Hassocks Parish Council Parking Working Group – Dale Avenue

***UPDATE* July 2018**

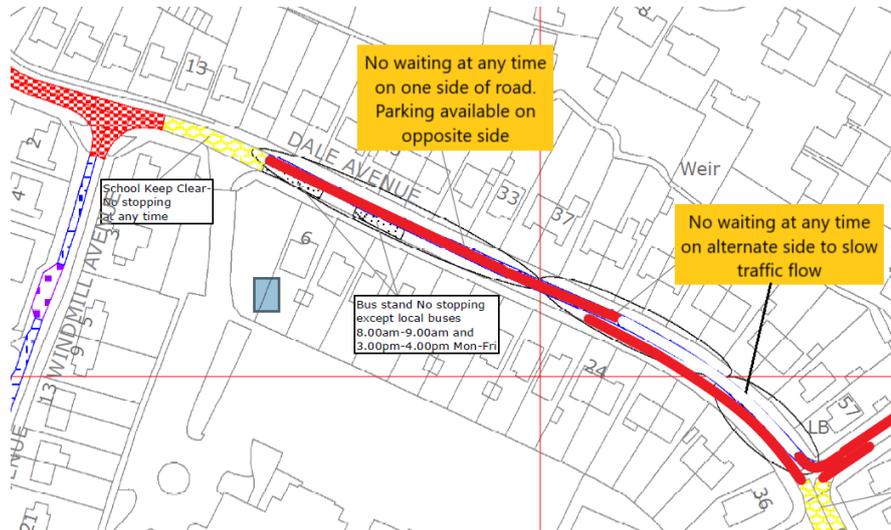
Following the recent Consultation for Stage 2 of the Hassocks Traffic and Parking scheme we made some adjustments to reflect the feedback received from Dale Avenue residents mainly related to timing of the restrictions and to access to Highlands Close. Initial review by WSCC Parking Scheme Team has indicated that both WSCC and Mid Sussex Parking Teams may object to the parking restrictions proposed in Dale Avenue. This is because Mid Sussex Enforcement Team has a limited number of Traffic Wardens and so are unable to effectively police the non-standard restrictions we proposed in Dale Avenue.

WSCC have therefore proposed that using double yellow lines instead will allow the Traffic Wardens to police Dale Avenue as part of their regular visits to Hassocks.

An alternative proposal has therefore been made which also takes on board resident's requests to reduce the speed of through traffic. It is shown in block red with yellow explanation boxes on the maps attached (*all existing/agreed restrictions are shown by red hatching and other colours*):

1. Double yellows from No 19 to 41 with parking available for visitors or residents on the opposite side of the road. (Note parking is allowed in the Bus Stand outside the times shown on the sign).
2. Double Yellows on alternate side from No 24 to 36 with parking on North side of road. This will create a Chicane effect to slow traffic.

3. Double Yellows into Highlands Close to allow easier access for residents

4. Alternate double yellows between Windmills school entrance and Lodge Lane which together with the bend is designed to slow traffic. Unrestricted parking will be available on the opposite sides of the road.
